From: andrea weiner <akweiner@gmail.com>
Sent: Wednesday, February 26, 2025 8:05 AM
To: planning
Subject: PA-T2-2024-00053

RE: Planning Action PA-T2-2024-00053
Subject Property. 231 Granite Street

Subject: Formal Objection and Concerns Regarding Planning Action PA-T2-2024-00053 – for
231 Granite Street

Fire Hydrant Location

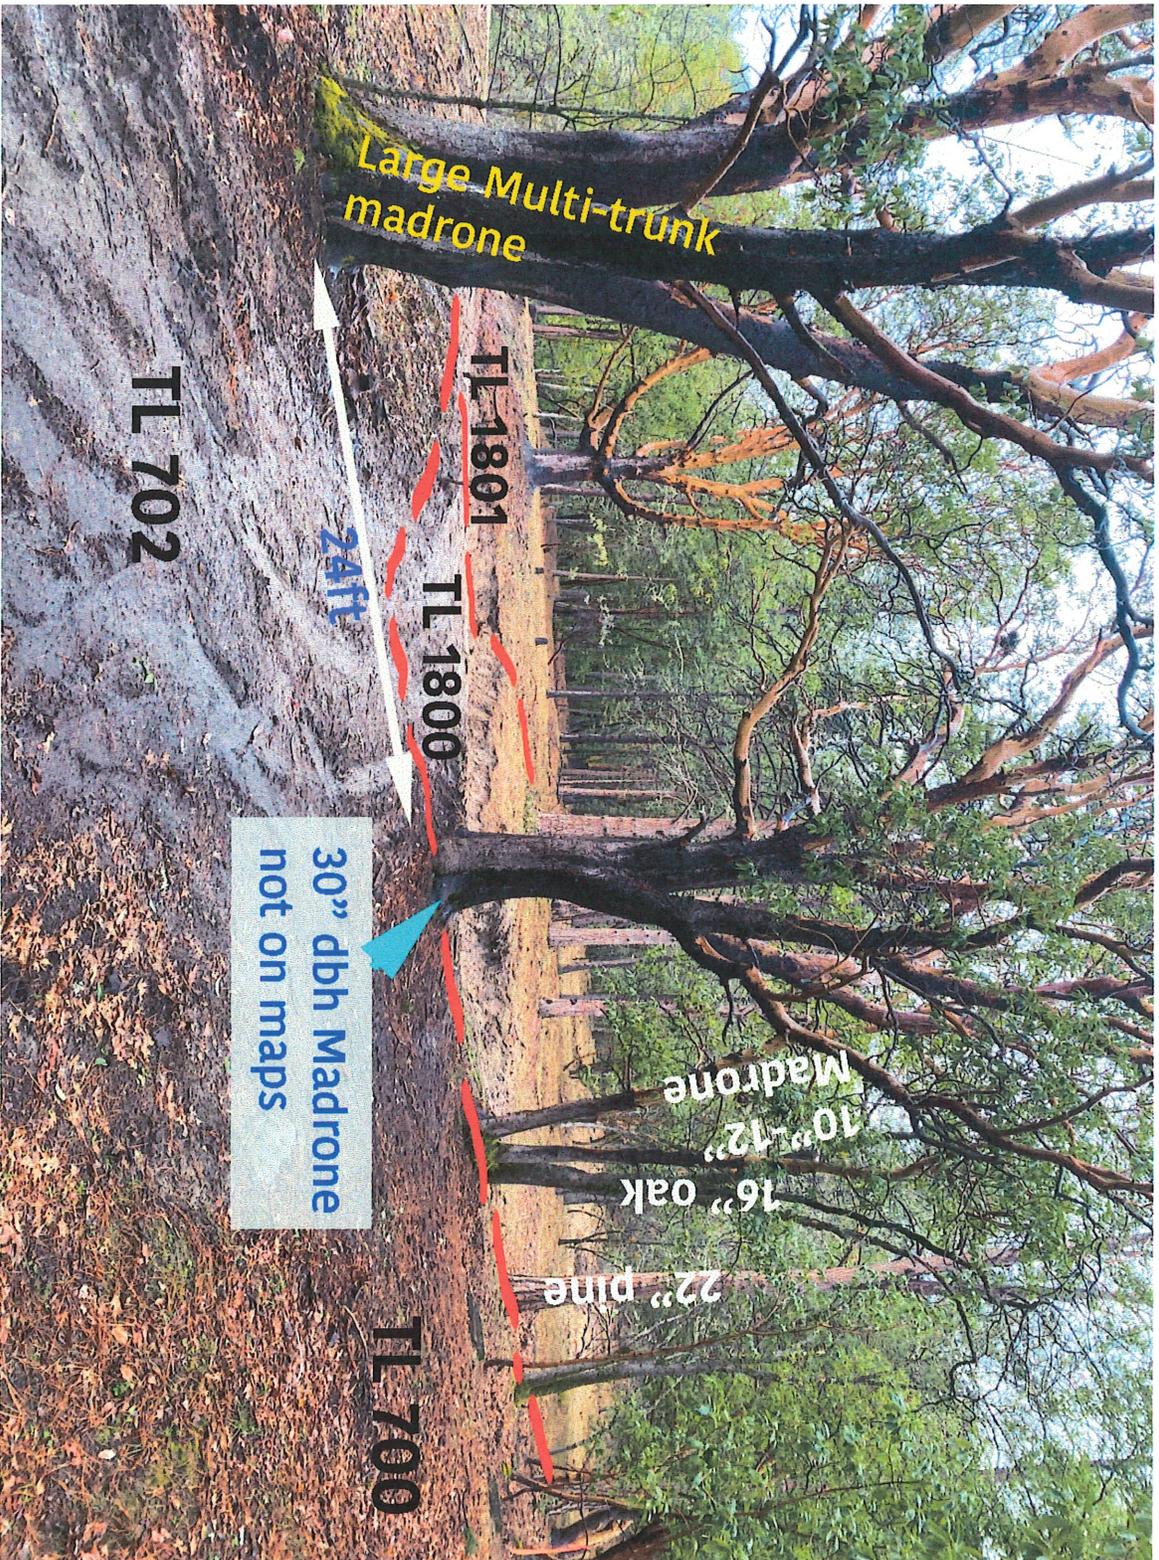
Fire Chief Shay asks for the distance to the private hydrant 'already on the easement road.' To our knowledge there is no hydrant on the driveway down to Granite St. There is a hydrant on the private driveway off Strawberry Lane, near 234 Strawberry Lane. Is this the hydrant referred to and does it being on a separate driveway affect the fire chiefs view?
